**STAFF REPORT TO THE PLANNING COMMISSION FOR PRELIMINARY PLAT REQUEST**

The layout of the Preliminary Plat of Schepers Farm, P.P. # 70-14-07-400-049 located at 8100 42<sup>nd</sup> Ave., zoned Low Density Residential (LDR), Georgetown Township, Ottawa County, Michigan. **This is a revision from the previous application submitted in 2023. The 2023 approval expired in June 2025.**

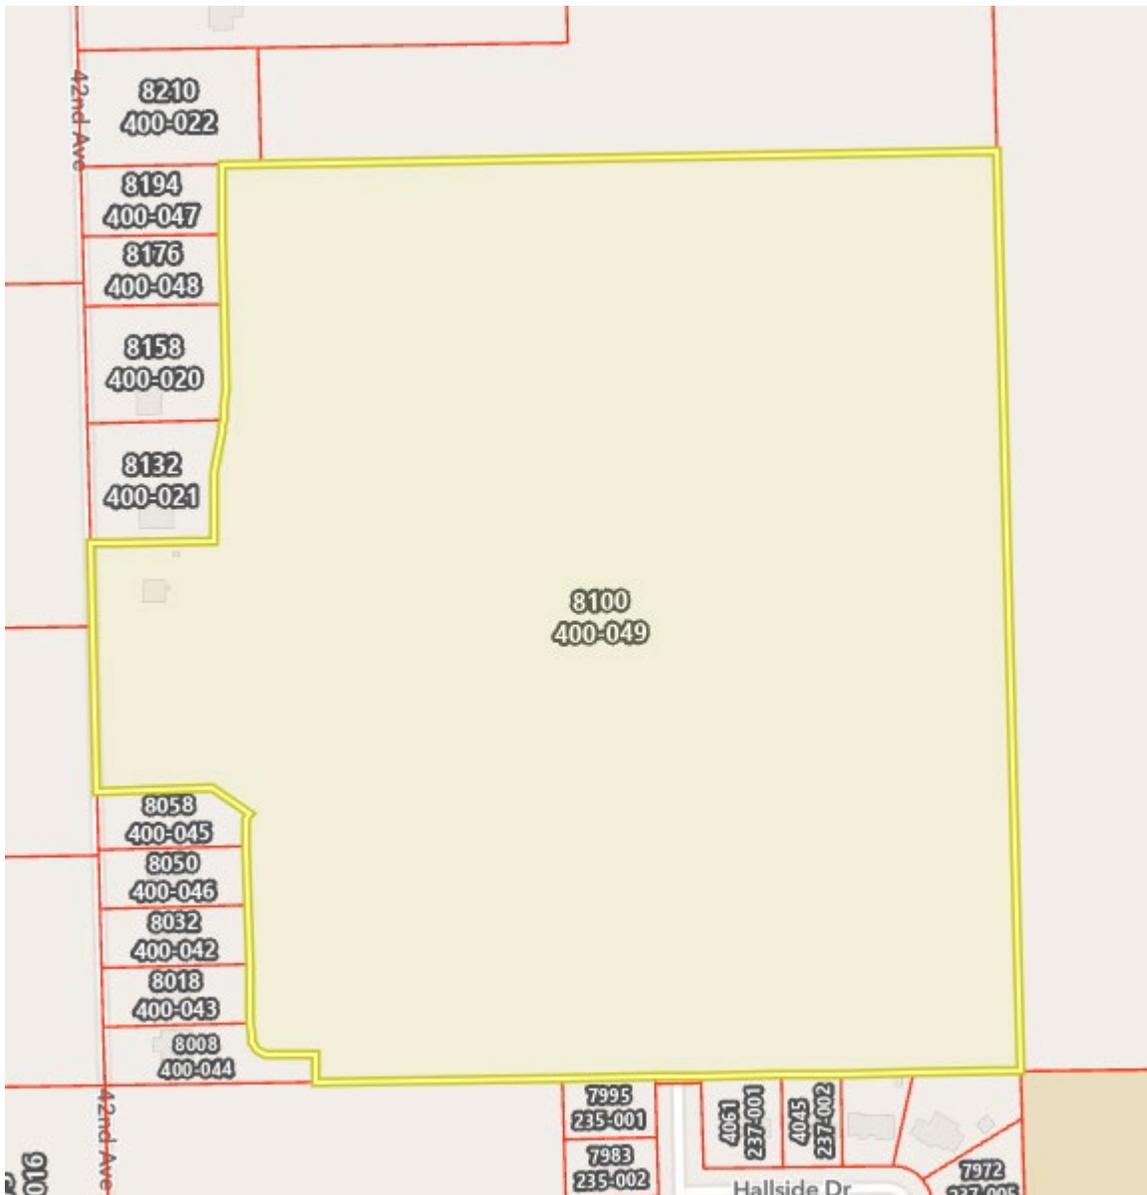
- a. The lots and building envelopes appear to meet ordinance requirements (all will be reviewed for exactness at the time building permit applications are submitted). Notes below are provided to identify specific features of lots.

- Lots 7 & 8 shall have driveways on Schepers Drive, **not 42<sup>nd</sup> Ave.**
  - Most lots are affected by a wetlands, detention areas, and/or a pond. These are situations noted to be created by the developer and would be considered to be **a self-created situation in case any variance requests are submitted in the future based on those circumstances.**

- b. The plan notes that there is a plat entry sign which may be built at the time of plat construction and notes that location is “optional.” It should be noted that the plat entry sign will require a sign permit and follow all applicable Township Ordinances. **If there will be a plat entry sign, a legal instrument detailing responsibility for ownership and maintenance shall be provided prior to final plat approval.**

- c. The plan indicates that the proposed storm sewer and detention basin is intended to be part of a 433 agreement and will be adopted by the Ottawa County Water Resources Commission.

- a. Building envelopes meet ordinance requirements. Envelopes will be reviewed for exactness at the time building permit applications are submitted.
- b. Most lots are affected by a drainage easement, detention areas and/or wetlands. These are situations noted to be created by the developer and would be considered to be **a self-created situation in case any variance requests are submitted in the future based on those circumstances.**

- c. All existing and proposed utilities shall be coordinated with the township DPW department
- d. The proposed plan shall be approved by Ottawa County Water Resources Commission.

- e. The proposed plan shall be approved by the Ottawa County Road Commission.
- f. All fees, including deferred assessments, shall be paid prior to the issuance of any building permits.

- g. If there will be a plat entry sign, a legal instrument detailing responsibility for ownership and maintenance shall be provided at the time of Final Plat approval.
